Access Compliance Report

Public Rights-of-Way (Curb Ramps)

Intersection ID: N/A	Main Street: 7TH_ST	Cross Street: N/A	Location: SE
ADA ID: 1F9526A991B3	Ramp Type: PerpDiag	Initial Pass/Fail: Pass	Overall Compliance: No
Severity Score: 0.25			
Codes/Mitigation Info/Possible Solution		Field Measurements/Component Compliance

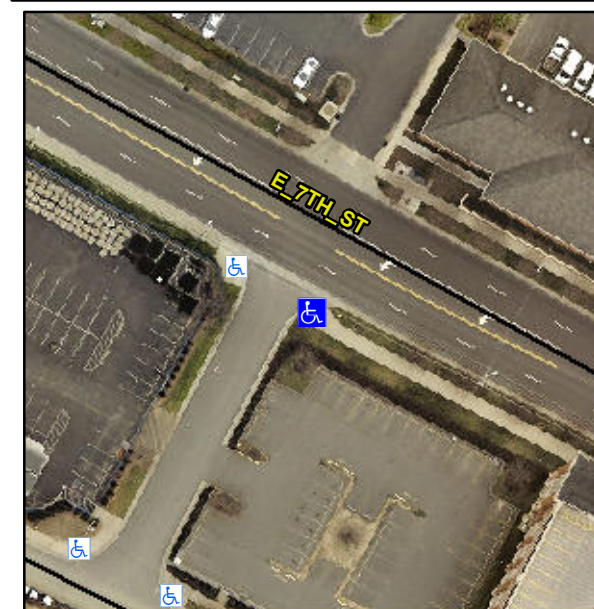
Not Found, R304.5.3

Compliance	Description	Data	Compliance	Description	Data
N/A	Ramp Length (in)	86.0	Yes	Ramp Slope (%)	5.5
Yes	Ramp Width (in)	48.0	No	Ramp XSlope (%)	4.4
N/A	Flare Type LT	Sloped	N/A	Flare Type RT	N/A
N/A	Flare Slope LT (%)	5.9	N/A	Flare Slope RT (%)	3.0
N/A	Flare Traversable LT?	No	N/A	Flare Traversable RT?	No
Yes	Landing Length (in)	61.0	Yes	DWS Provided?	Yes
Yes	Landing Width (in)	48.0	Yes	DWS Contrast?	Yes
Yes	Landing Slope (%)	1.2	Yes	DWS Length (in)	24.5
Yes	Landing X Slope (%)	1.3	Yes	DWS Full Width?	Yes
N/A	Landing Curb? (Y/N)	No	Yes	DWS Offset (in)	1.5
N/A	Shared Landing?	No			
Yes	Gutter Ponding?	No	Yes	Gutter Slope (%)	1.5
Yes	Gutter Lip Ht (in)	0.0	Yes	Gutter X Slope (%)	0.7
N/A	Painted X Walk1?	No	N/A	Painted X Walk2?	No
	X Walk 1 Direction	To NE		X Walk 2 Direction	To NW
N/A	X Walk 1 Width (in)	N/A	N/A	X Walk 2 Width (in)	N/A
	X Walk 1 Slope (%)	4.8		X Walk 2 Slope (%)	2.4
	X Walk 1 X Slope (%)	0.6		X Walk 2 X Slope (%)	2.0

Remove & Replace Curb Ramp With Two New Directional Ramps or Equivalent.
